City of Carpinteria
Architectural Review Board Agenda
Thursday, March 26, 2026
Council Chamber, 5775 Carpinteria Avenue,
Carpinteria, CA 93013

**CITY OF CARPINTERIA
ARCHITECTURAL REVIEW BOARD
Meeting of March 26, 2026**

Project: 25-2372-CDP/ARB **Planner:** Bret McNulty
Address: 5538 Canalino Drive
APN: 003-382-012
Zoning: Single Family Residential (6-R-1)
Applicant: Robert Mahterian, architect, for Keith and Lesley Marvin

Existing Single Family Residence Remodel
5583 Canalino Drive
Project #25-2372-CDP/ARB
Preliminary ARB Review
March 26, 2026

PROPOSED EXTERIOR
ELEVATIONS

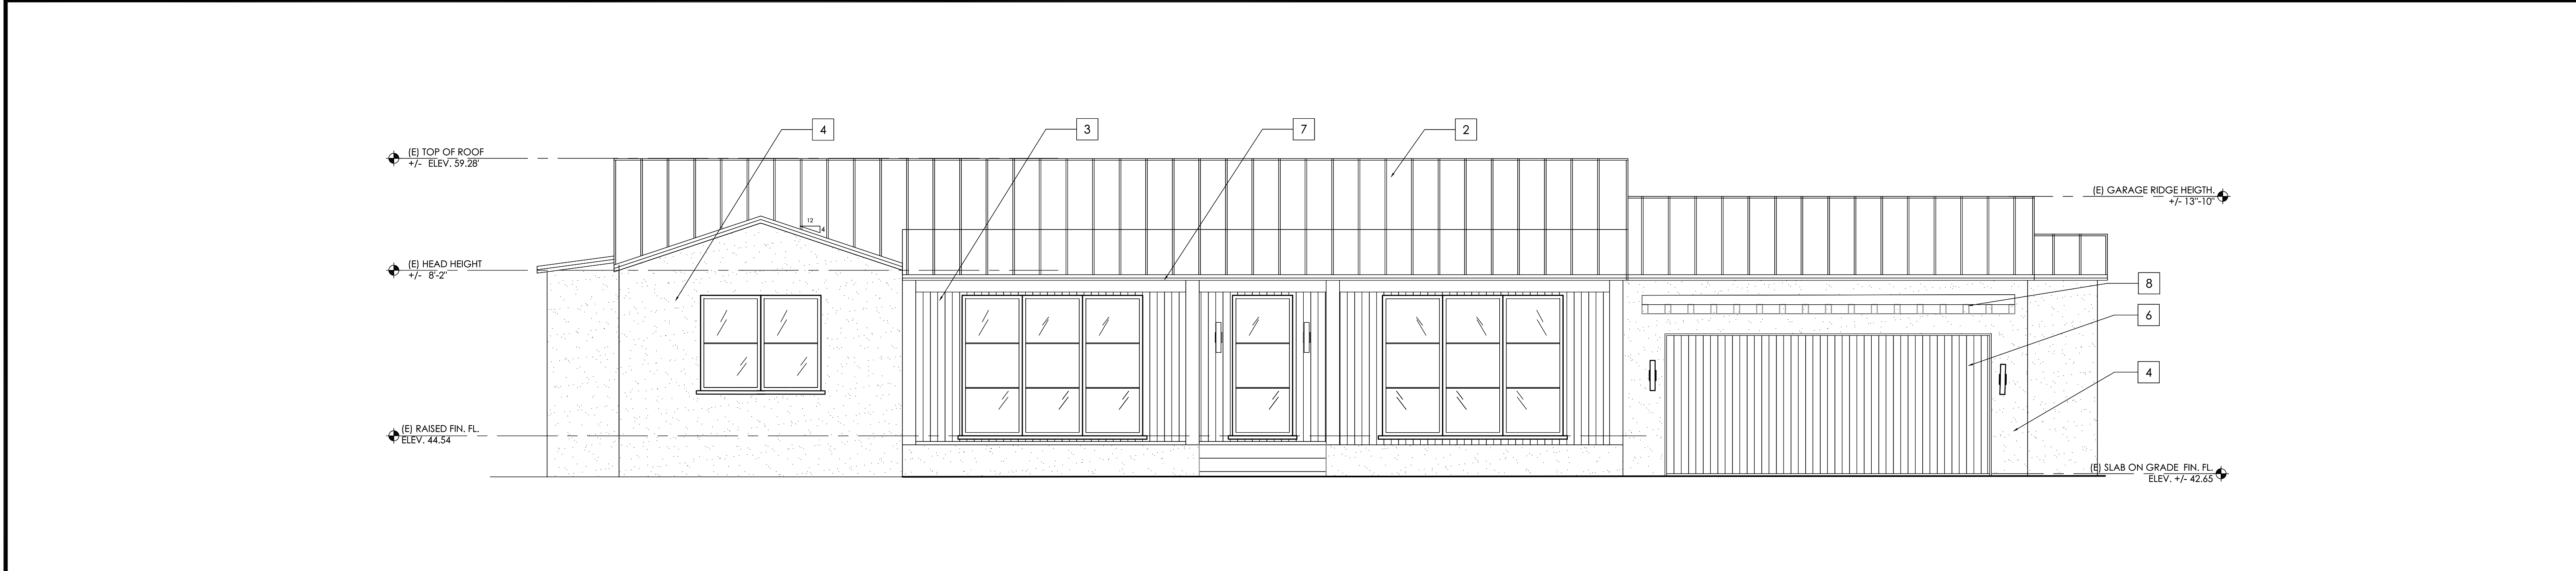
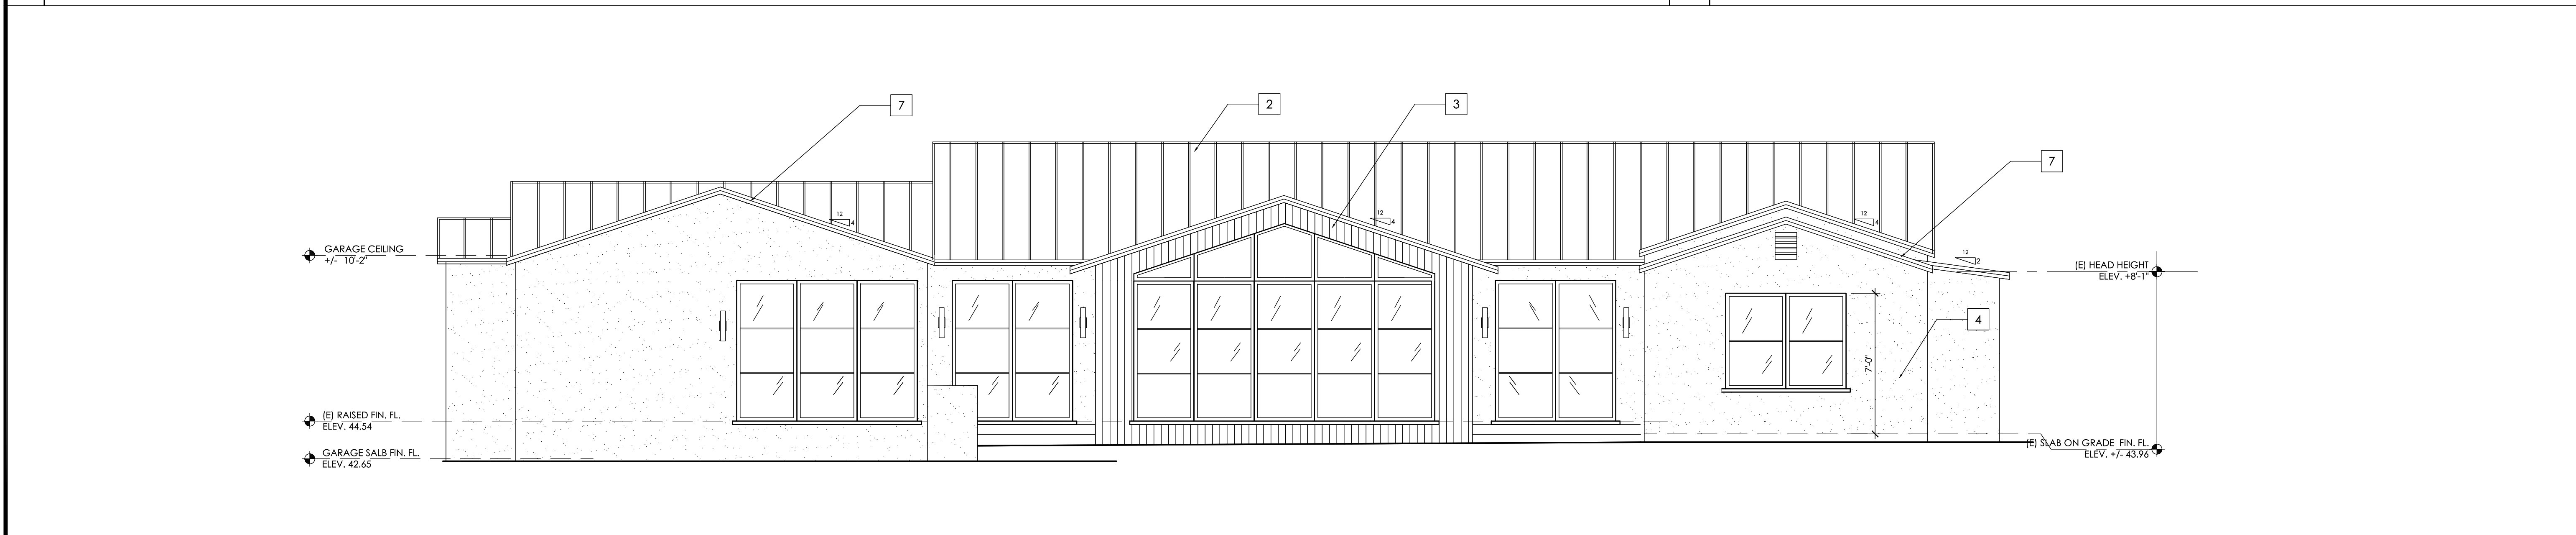
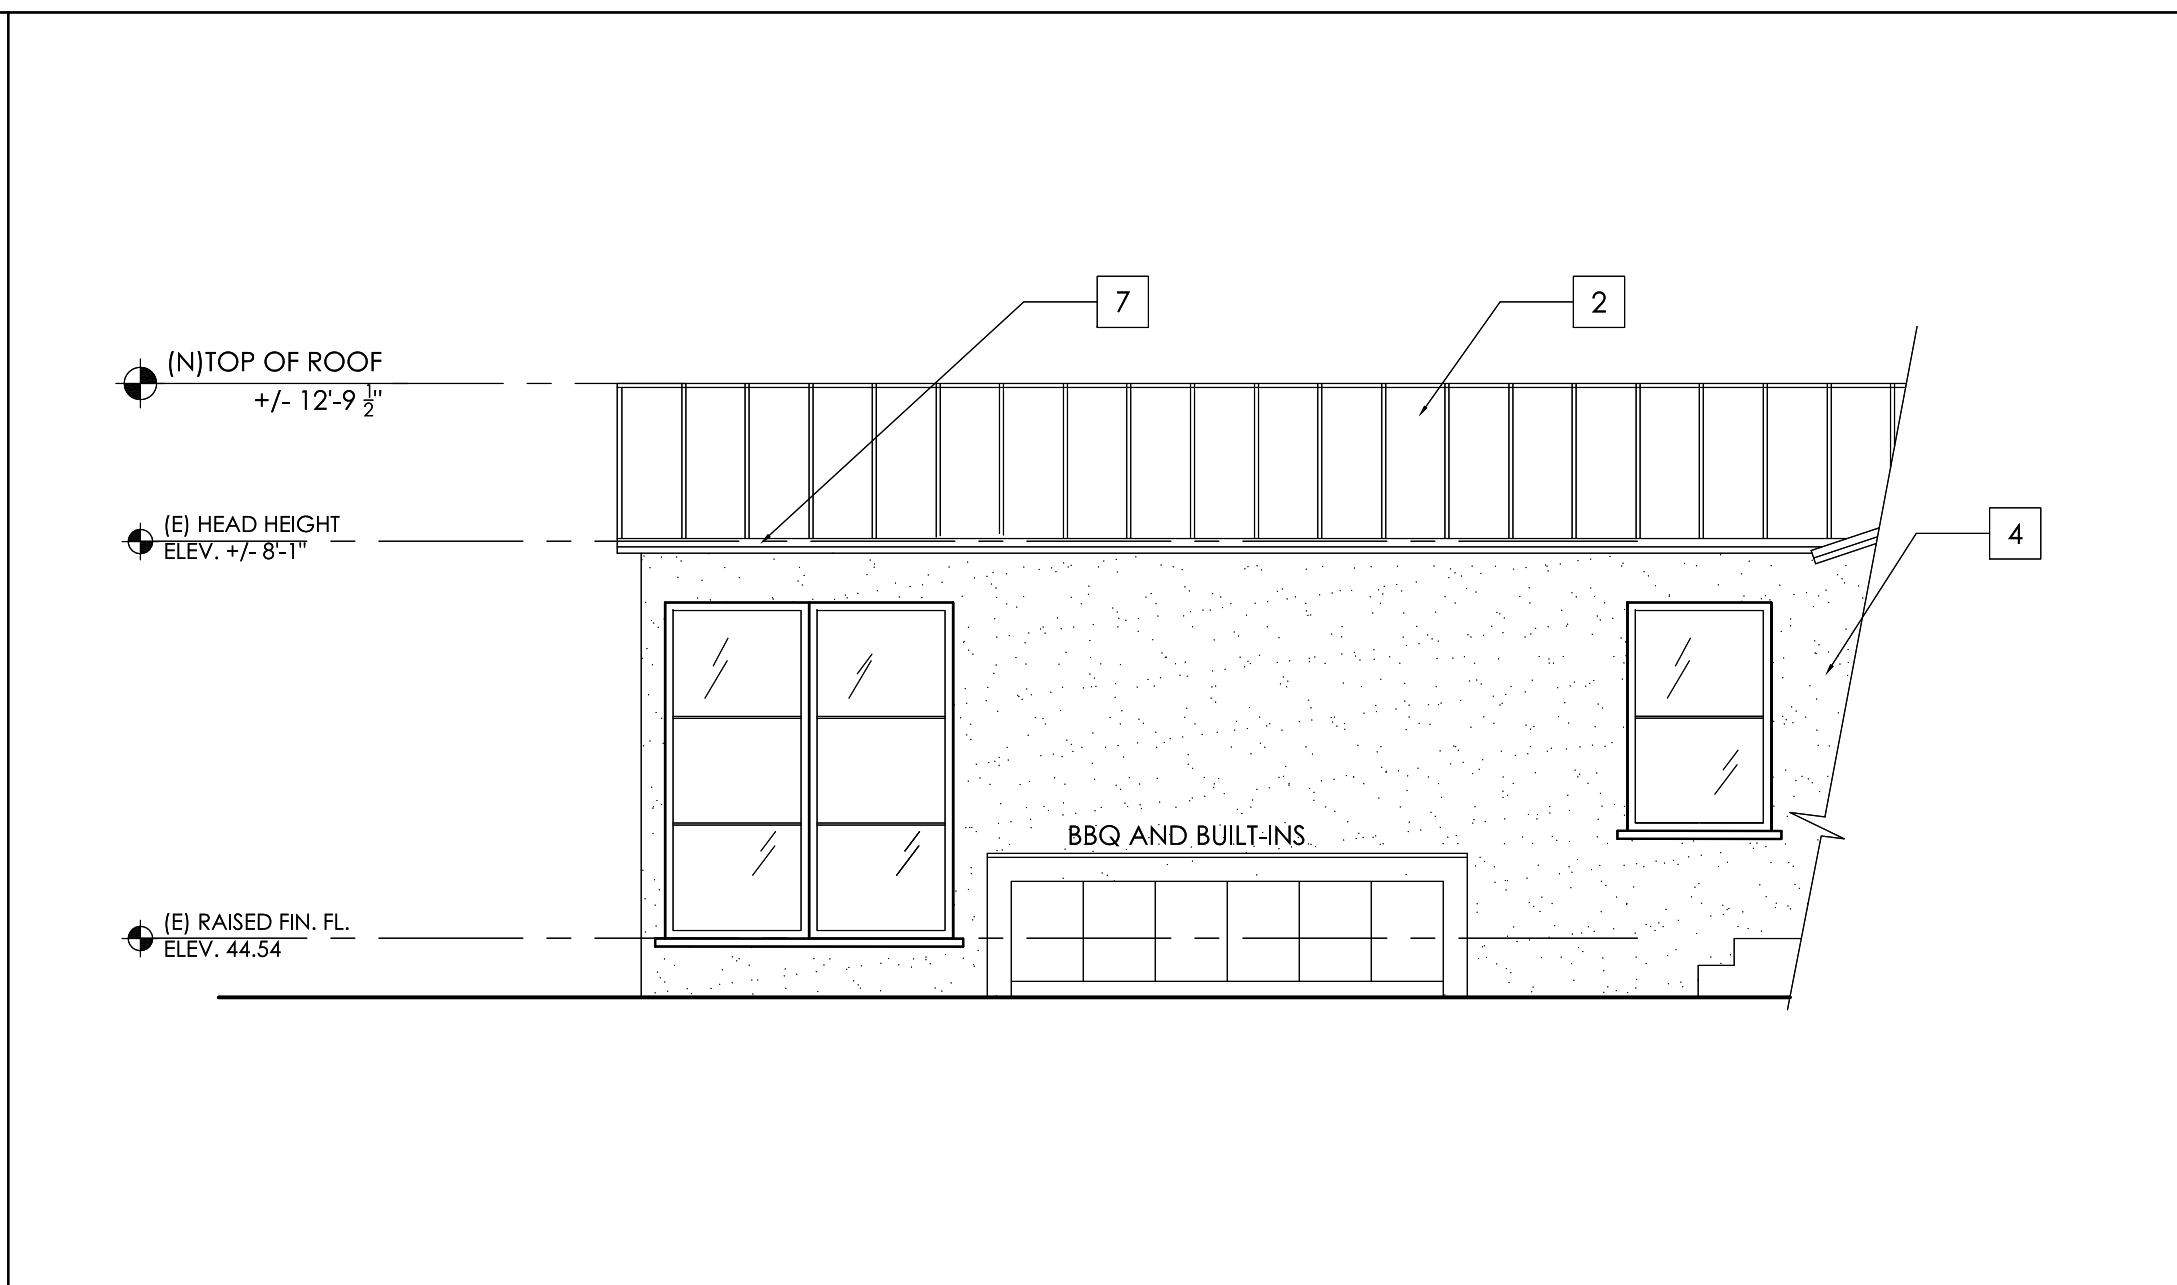
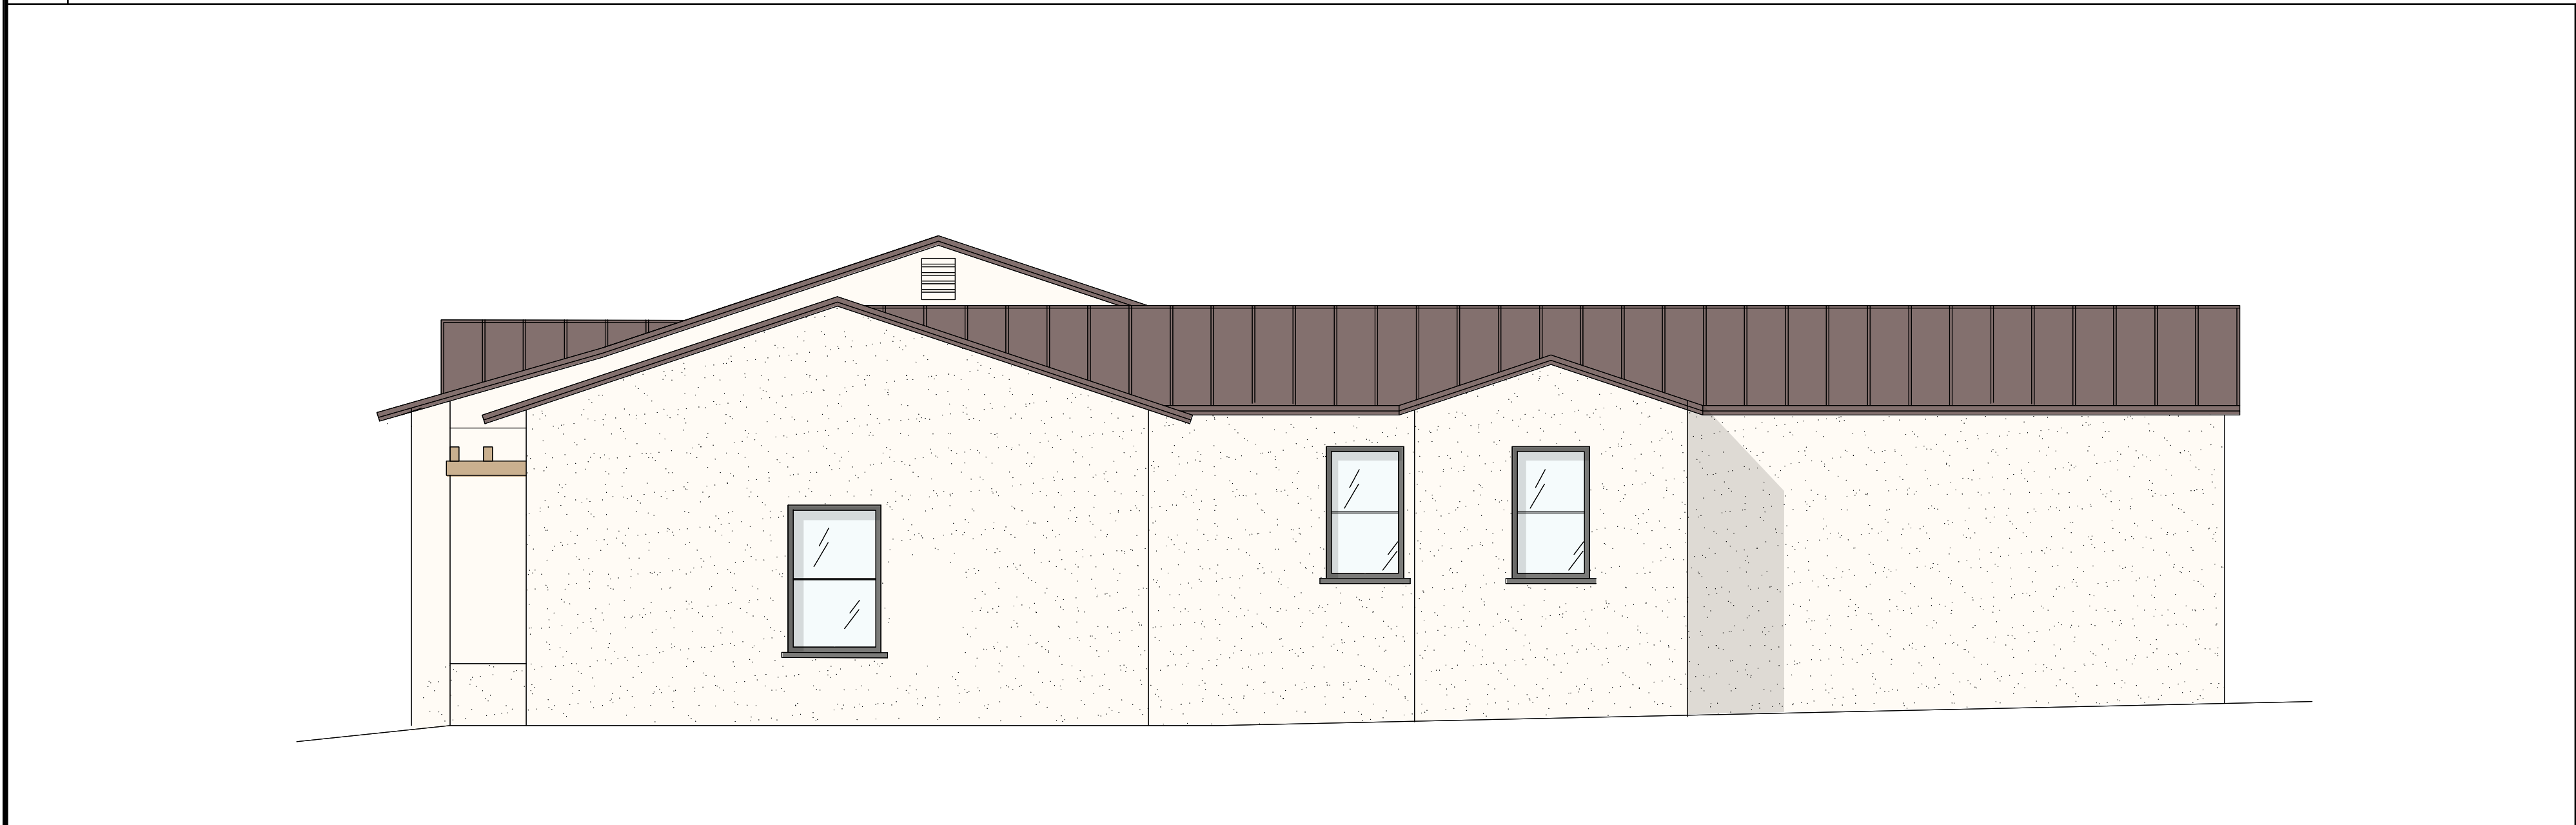
The ARB members should comment on the proposed massing, height, architectural style, consistency with the sub area objectives.

The proposed materials are typical for a modern house, such as cedar wood siding and light colored stucco with a darker metal roof. The proposed materials would impart a contrast with a darker brown siding and dark bronze window frames that are tied together by the use of lighter (stone and rust) colors. The use of these materials in concert with the chosen architectural style lends the home a mix of earthen tones impart a character that is unique and compatible with the colors and architectural designs and one-story residences in this neighborhood.
